Re: Florida Power & Light Company
Proposed Turkey Point Units 6 and 7
Docket Nos. 52-040 and 52-041
Response to NRC Environmental Request for Additional Information Letter
1103071 (RAI 5498) Environmental Standard Review Plan
Section 5.7 – Meteorology and Air Quality Impacts

Proposed Turkey Point Units 6 and 7
Docket Nos. 52-040 and 52-041
L-2011-155 Page 2

NRC RAI Number: EIS 05.07-2 (RAI 5498)

Figure 5.3-1 Predicted Monthly Salt Deposition

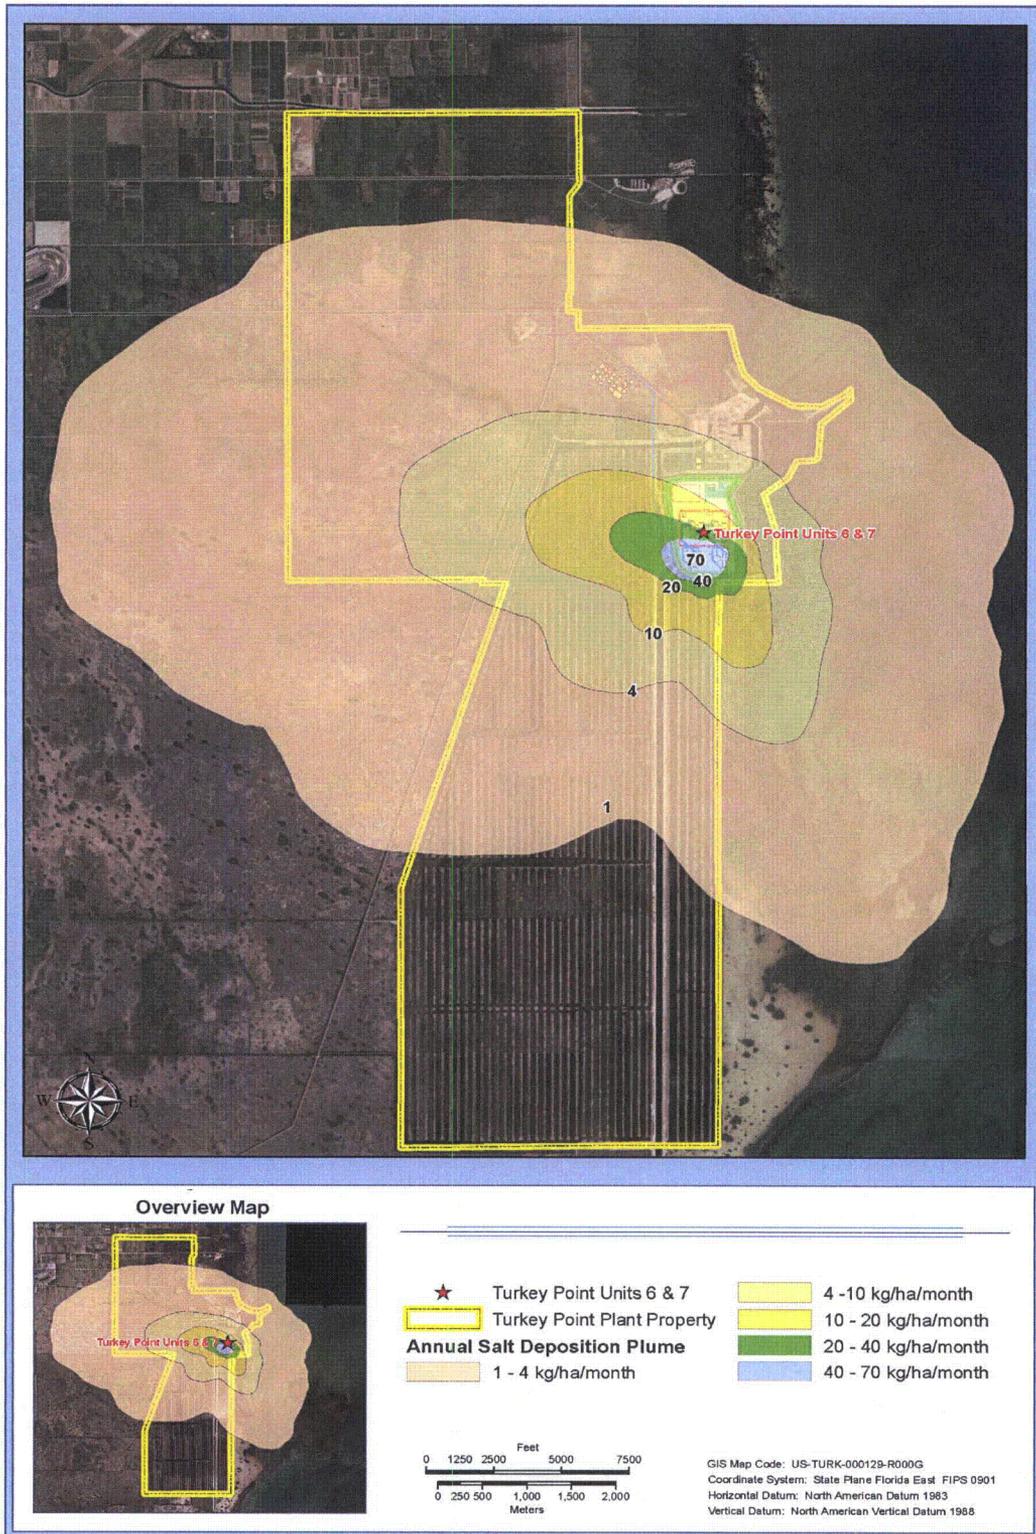
Provide an explanation as to why one cooling tower particle size distribution is different from that of the other five towers. Also provide information that documents and supports the particle size distribution used in this analysis using the TDS of 50,000 ppm.

Provide an explanation as to why this one cooling tower is different from the other five towers. Also provide information that documents and supports the particle size distribution used in this analysis using the TDS of 50,000 ppm.

The particle diameter size distribution listed for cooling tower “TP7W01” was incorrect. The particle diameter size distribution is identical for all six cooling towers. This particle diameter size distribution for saltwater, given at a concentration of 50,000 ppm, when the radial collector wells are used for the circulating water system (CWS) cooling towers, was based on Table 1 of Reisman and Frisbie (2001),

The revised modeling approach resulted in a slightly larger salt deposition plume, as depicted on Figure 5.3-1. However, the salt deposition area of greater than 10 kg/ha/mo (the level that could cause leaf damage in many species) would generally be confined to the plant property and is little changed from the original modeling approach. In addition, impacts to the crocodile areas (Figure 5.3-2) are also little changed from the original modeling approach. It is important to note that the AERMOD modeling assumed the radial collector wells are in operation full-time, resulting in a continuous TDS concentration of 50,000 ppm in the saltwater droplet emission. The radial collector wells are the back-up CWS water source that will be used intermittently when the primary source – reclaimed water – is not available. Therefore, the annual salt deposition plume, based on the assumption of continual radial collector wells operation, is likely much larger than what would be expected from reclaimed water use in the CWS.

The maximum predicted salt deposition rate to the industrial wastewater facility in the vicinity of the cooling towers ranges from **140 to 7080** kg/ha/month (annual basis; see Figure 5.3-1). This annualized salt deposition range of **140 to 7080** kg/ha/month was normalized to salinity based on the annual site rainfall (approximately 58 inches annually). The resulting salinity range was calculated to be approximately **0.00080-0.03** to 0.06 parts per thousand (ppt).

....As is depicted in Figure 5.3-2, the majority of juvenile crocodile refugia are south of the area of maximum **where the majority of salt deposition occurs (i.e., areas greater than 10 kg/ha/month).**

Revised ER Figures 5.3-1 and 5.3-2 will be included in a future COLA revision to reflect the RAI response:
